# Technical Service Bulletin

## 26 Noises are heard from the exhaust system at idle speed

26 20 39 2058998/1 March 24, 2020.

Model(s)	Year	VIN Range	Vehicle-Specific Equipment
RS4, RS5	2018 - 2019	All	Not Applicable

**Figure 1.** Old rear silencer.

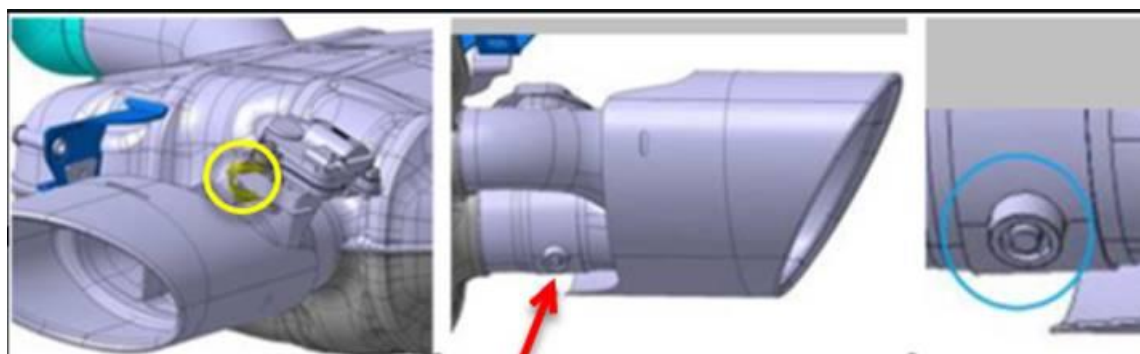
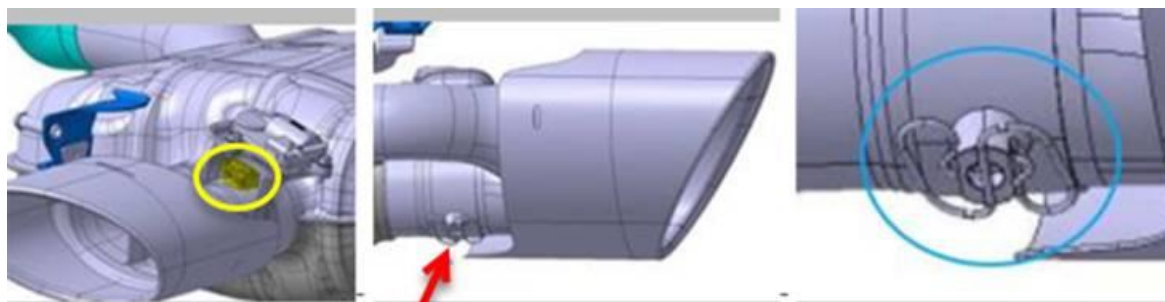
- A. Old version: C-bar (marked yellow) and floating bearing (blue). **It is not compatible with an optimized control motor.** The complete rear silencer has to be replaced.

- B. Optimized version: claw coupling (marked yellow) with spring lock (blue). Check which version of the control motor is fitted: If a new control motor (part number 8S0 133 246 D) has not yet been installed, replace it individually on the exhaust flap with the concern.

An optimized rear silencer was developed and put into production. Some vehicles are already fitted with the optimized rear silencer (factory-fitted, with claw coupling and spring lock), but still have an old control motor (part number 8S0 133 246 A).
